**MSAD No. 75 Envelope Analysis  
Report  
May 31, 2021  
*Updated July 2021*  
Prepared by: CHA Architecture**

The MSAD No. 75 School District contracted with CHA Architecture, P.C. to conduct an analysis of the existing cladding at the Mt. Ararat Middle School and make recommendations for recladding the existing building.

**MIDDLE SCHOOL ENEVELOPE**  
 50 REPUBLIC AVENUE TOPSHAM, ME 04086

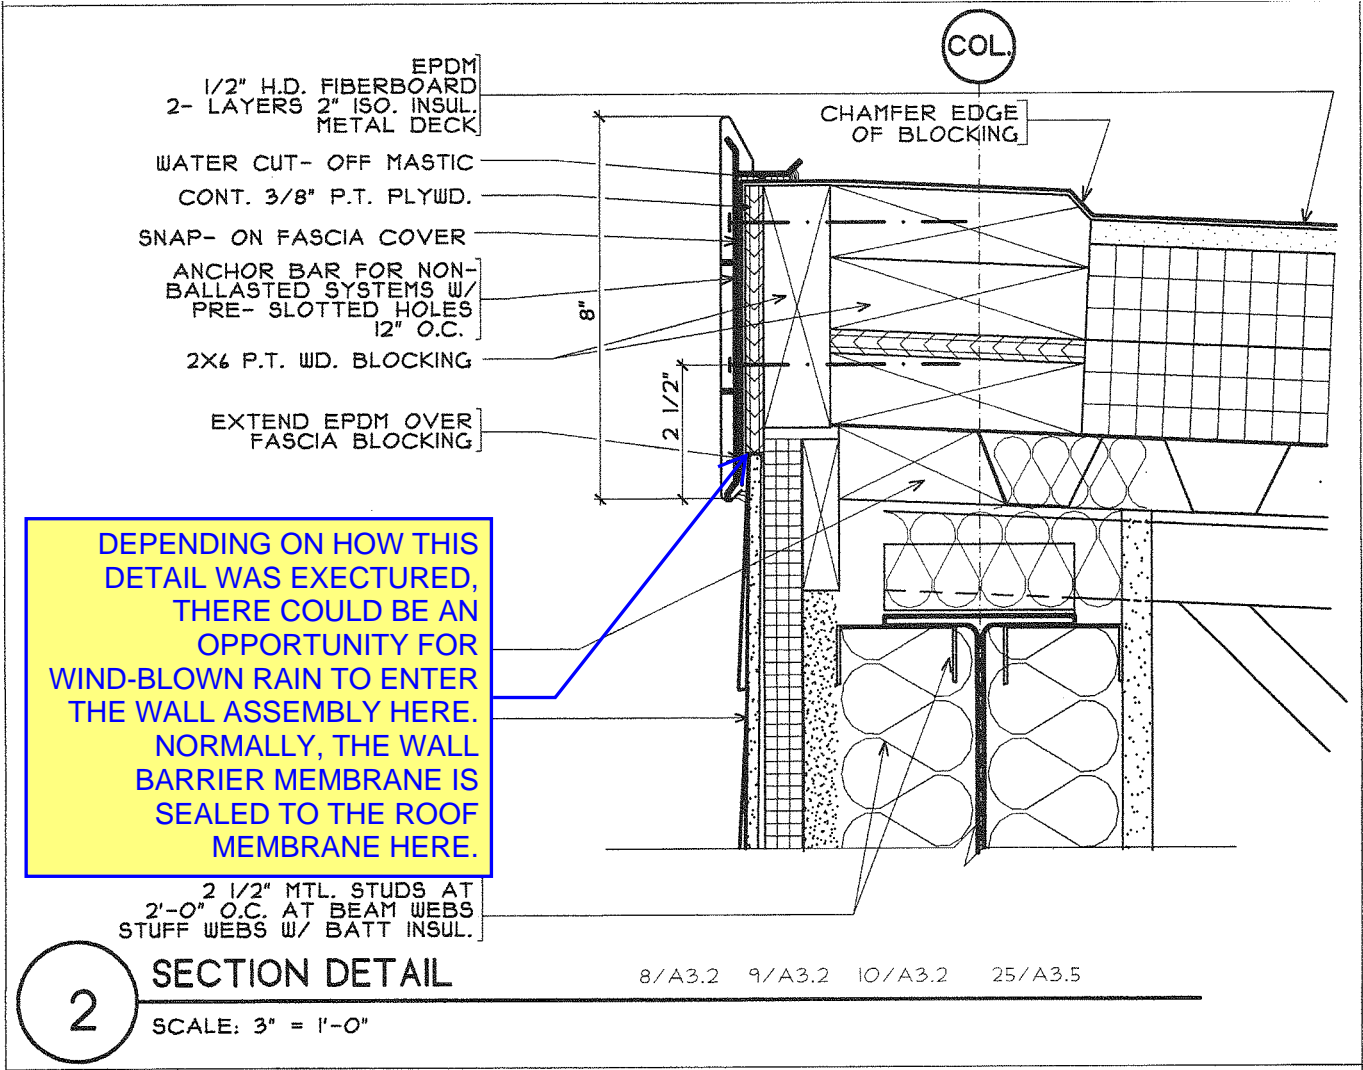
It's our assessment that the damage observed on the faces and edges of fiber cement clapboards is part of the natural course of its service life. Even low-maintenance cladding materials like fiber cement can be expected to deteriorate over time due to exposure to the weather. It is possible that their lifespan was shorted by being in direct contact with the XPS insulation

boards. The hairline space between the two materials can hold water instead of allowing it to drain away. Providing even a small, but continuous ventilation plane between the materials may have slowed the moisture damage to the clapboards.

### HEAD DETAIL - FIBER CEMENT SIDING CONDITION

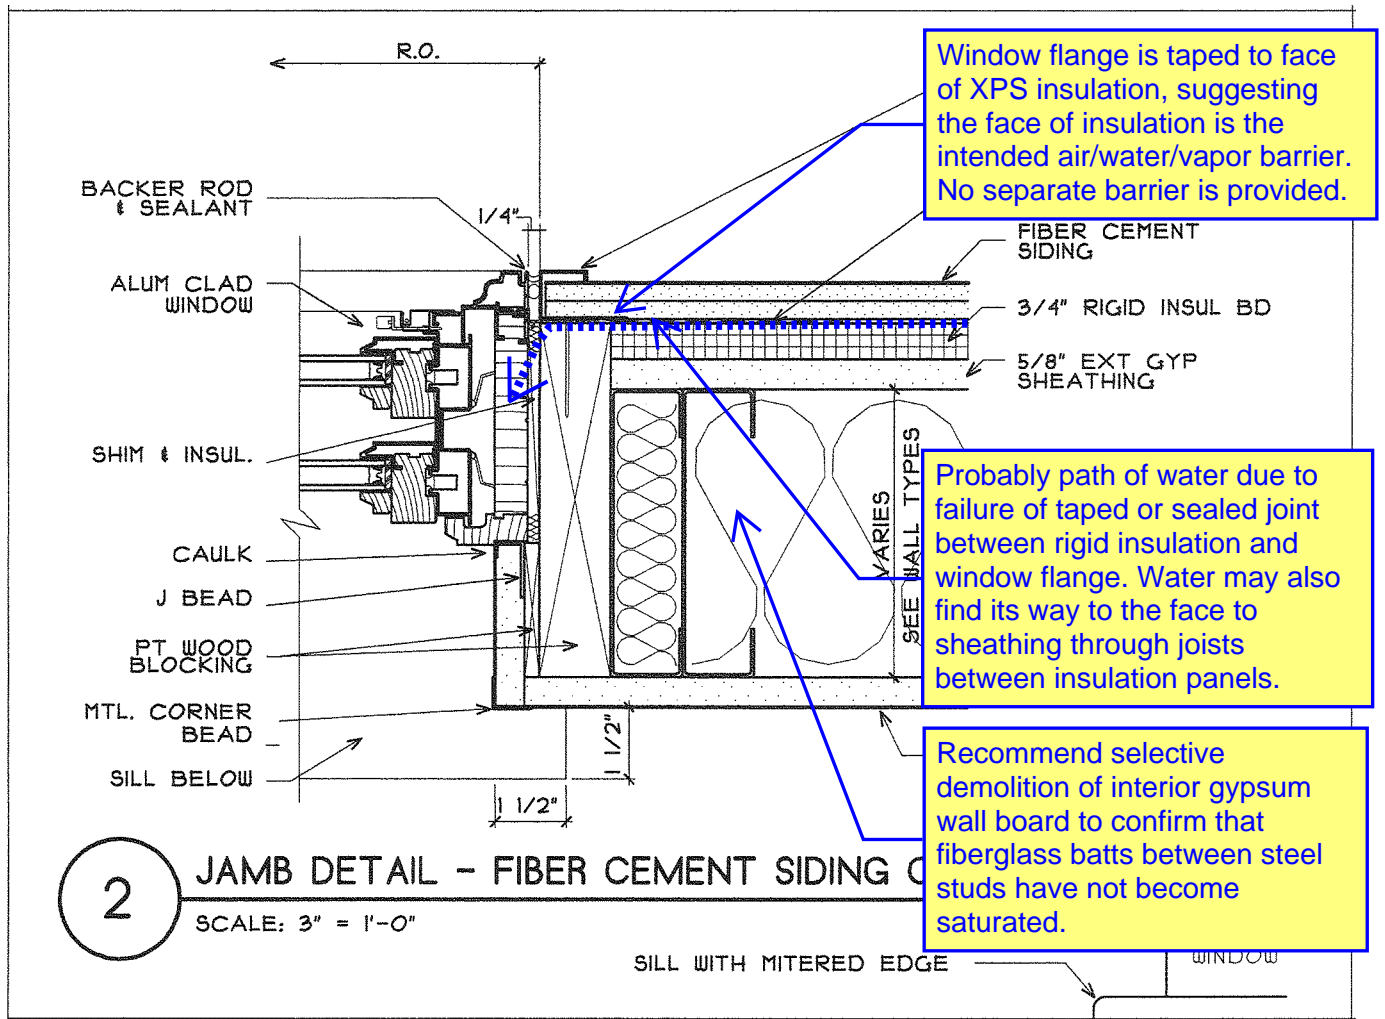
Installed condition does not match detail in some locations. U-shaped metal trim at window heads creates a trough that holds water against the FCS, leading to delamination and dissolution.

U-shaped trim also concentrates water flow to the jambs, instead of allowing it to drip along the length of the window head. This concentrated flow is likely to cause delamination and dissolution of FCS at cut edges of clapboards, particularly since sealant is present between clap board edges and jamb trim.

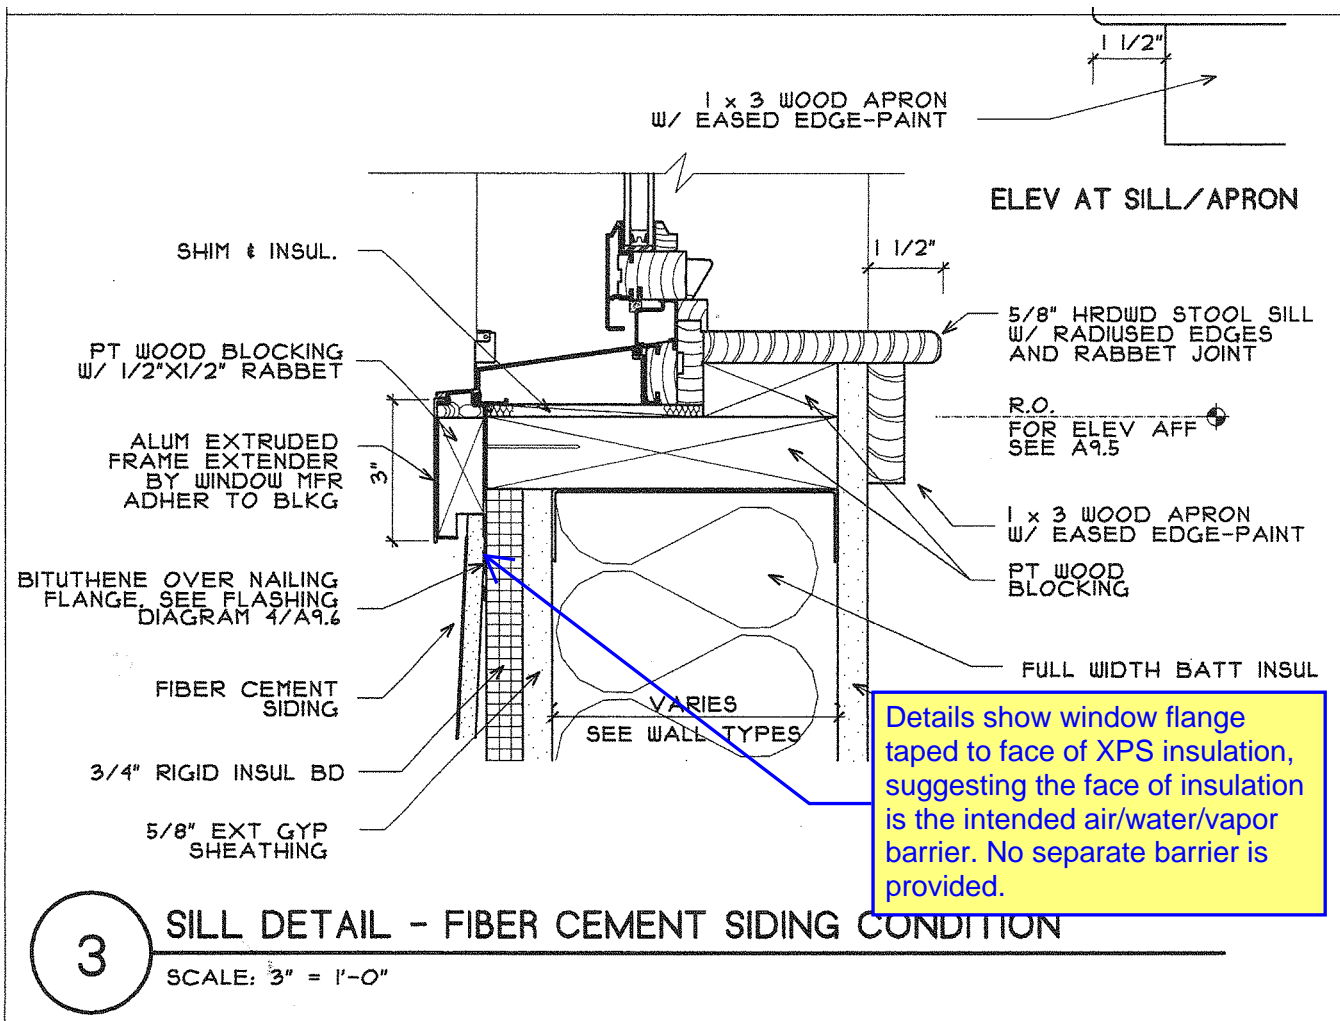
Another variation includes what appears to be head drip flashing, bent upwards to form a trough. Metal jamb trim is provided here to receive the clapboard ends, and substantial amount of sealant has been provided between clapboard ends and metal trim and between the metal trim and a separate piece of vertical window trim.

Sealant is a double-edged sword. When properly applied, sealant is part of a system that keeps water out of a wall assembly. Where water has already infiltrated the wall assembly, sealant can have a detrimental affect of trapping water with the wall assembly.

This variation of the window jamb condition resembles the drawn detail, with the addition of sealant between the FCS clapboards and metal J-trim.

The use of flanged windows is assumed based on the construction details. It's possible that if windows without flanges were installed, creating a different and possibly more complicated condition at window perimeters.
